STAFF FINDINGS:

I move that the Commission issue a certificate of appropriateness for the application at 553 South First Street, a contributing property in the Old West Side Historic District, to construct a 52 square foot rear addition with a balcony on top; replace the door to the balcony; infill one of two front doors and replace the remaining door; remove an attic exhaust fan in the rear gable and replace it with a circular window; infill a second-floor rear window and install a new window nearby; infill a basement window under the front porch; install a backyard patio; and construct two new accessory structures. As proposed, the work is compatible in exterior design, arrangement, texture, material and relationship to the rest of the building and the surrounding area and meets *The Secretary of the Interior's Standards for Rehabilitation* and *Guidelines for Rehabilitating Historic Buildings*, in particular standards 2, 5, 6, 9, and 10 and the guidelines for building site, addition, roofs, and windows, as well as the *Ann Arbor Historic District Design Guidelines*, in particular the guidelines for additions, doors, lighting, and residential accessory structures.

LIEBSCHUTZ &

EAST ELEVATION (PROPOSED)

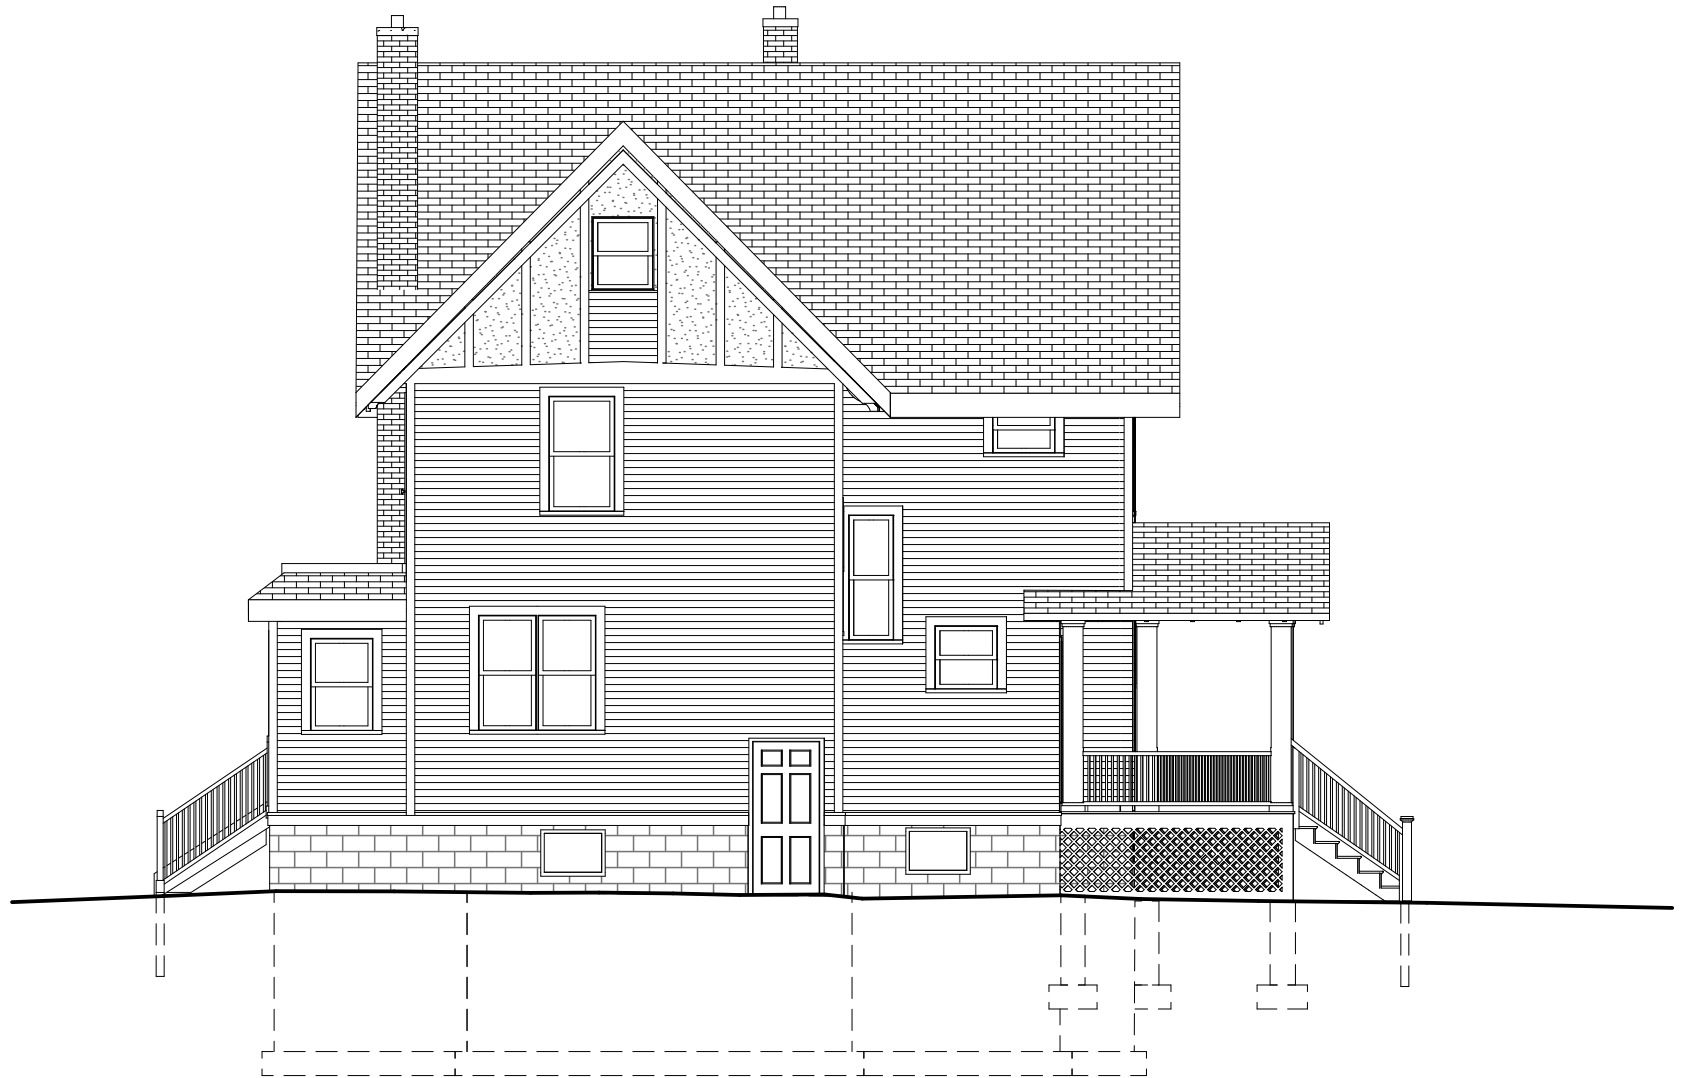
1. *Addition.* The house has a small one-story rear wing that was originally half living space and half covered porch. At some point after 1948 the porch was enclosed and a roofdeck was installed on top. The space currently contains a mudroom and powder room. The application proposes to rebuild the rear wing on a crawlspace and bump out the back wall an additional three feet. The original south wall would remain, and there is an inset of 8" at the southeast corner to preserve the original rear corner of the wing. The addition would add 52 square feet. A new back door with textured privacy glass and a prairie style muntin pattern on the window is proposed. While the design is not consistent with the style of the house, staff has no concerns that it will be perceived as a historic door.

2. *Balcony.* On top of the enlarged rear wing would be a roof deck/balcony with an aluminum guardrail. There is an existing door to the balcony that was likely installed when the rear porch was enclosed. The door appears to be old but was added sometime after 1948,

possibly reused from elsewhere on this house or from a different one. The application proposes to replace this door with a new wood door with one tall lite to allow more natural light into the house.

GARAGE ELEVATIONS (WEST)

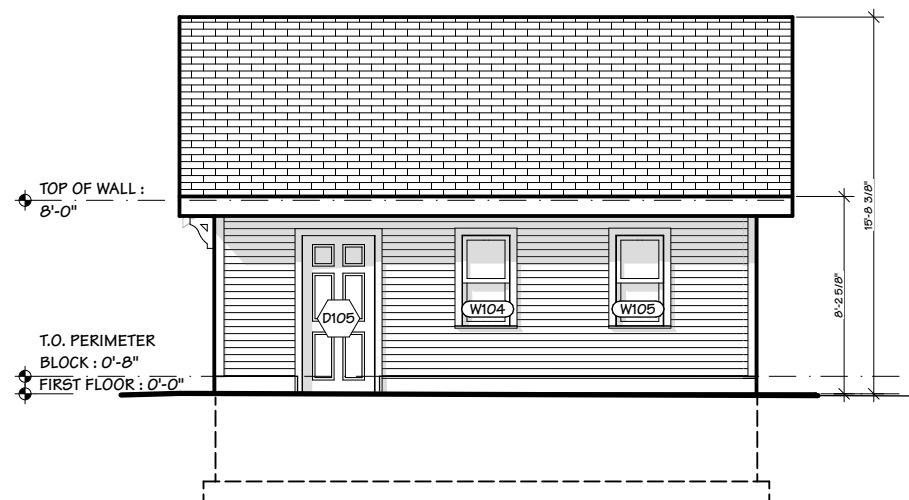
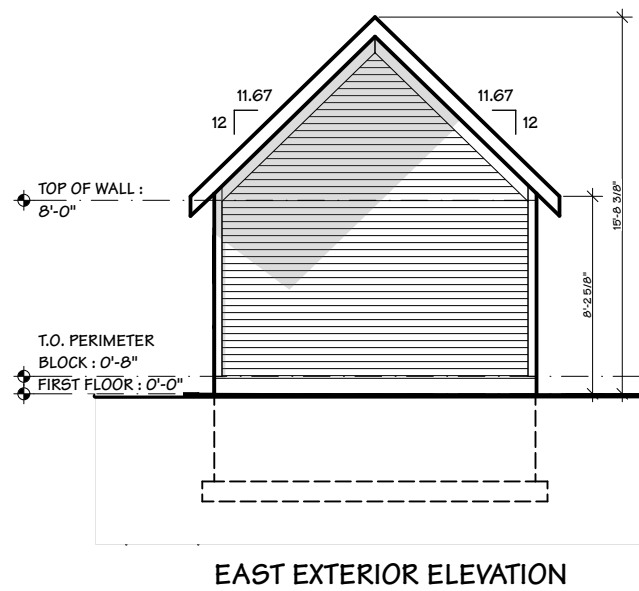
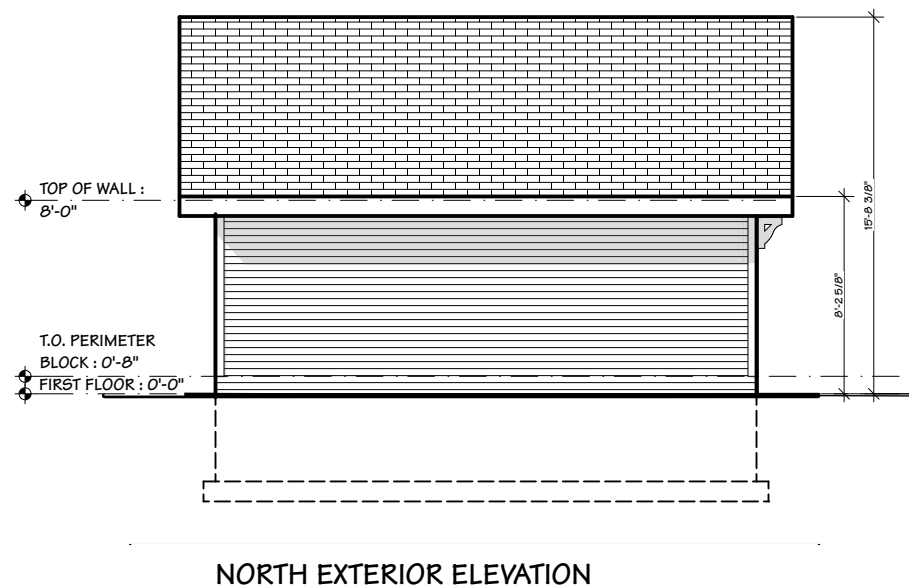
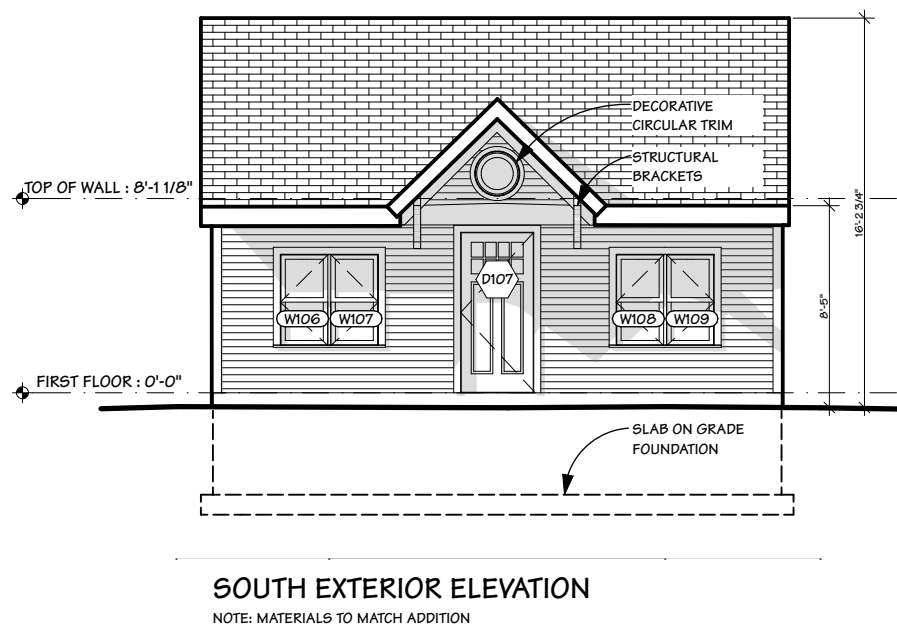
7. *Garage and ADU.* Two accessory structures of approximately the same size are proposed in the backyard. They are located in tandem at the end of the driveway, approximately 12' behind the new addition. There was historically a shed or small garage located in this rear corner of the yard. The two structures' placement is buffered by accessory structures on neighboring properties on two sides, and the ADU is blocked from view by the garage. This is an original city lot that has not been divided.

The garage is 15'9" tall with double hung windows, an insulated steel overhead door, and a six-panel wood person door. The ADU is 16'3" tall. It has simulated double hung casement windows and a bracketed gable awning over a centered wood front door. Both propose to use 4" fiber cement lap siding and fiber cement trim to match what's proposed

FRONT DOOR (PAGE 1/2)

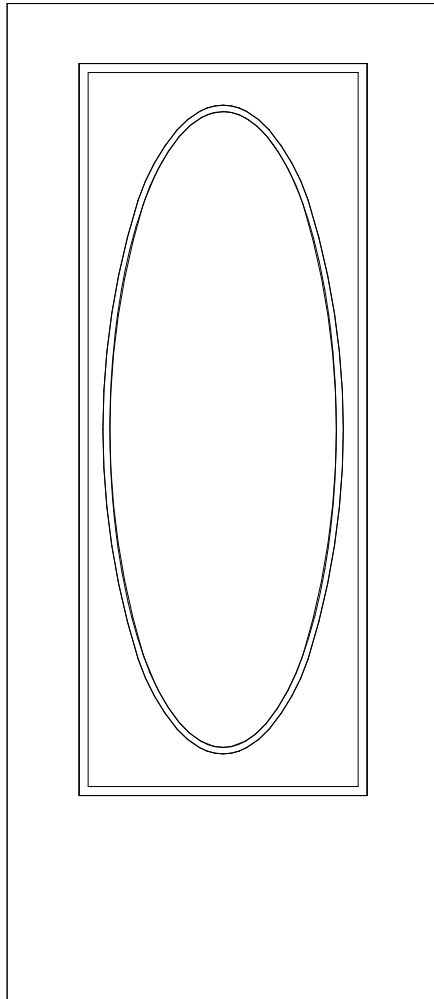
The remaining non-original front door (but in the original location) is proposed to be replaced with a wood door with an oval leaded glass window. A previous owner documented that a door with an oval window existed here. Staff believes that the style and materials are appropriate for the house, especially given this testimonial.
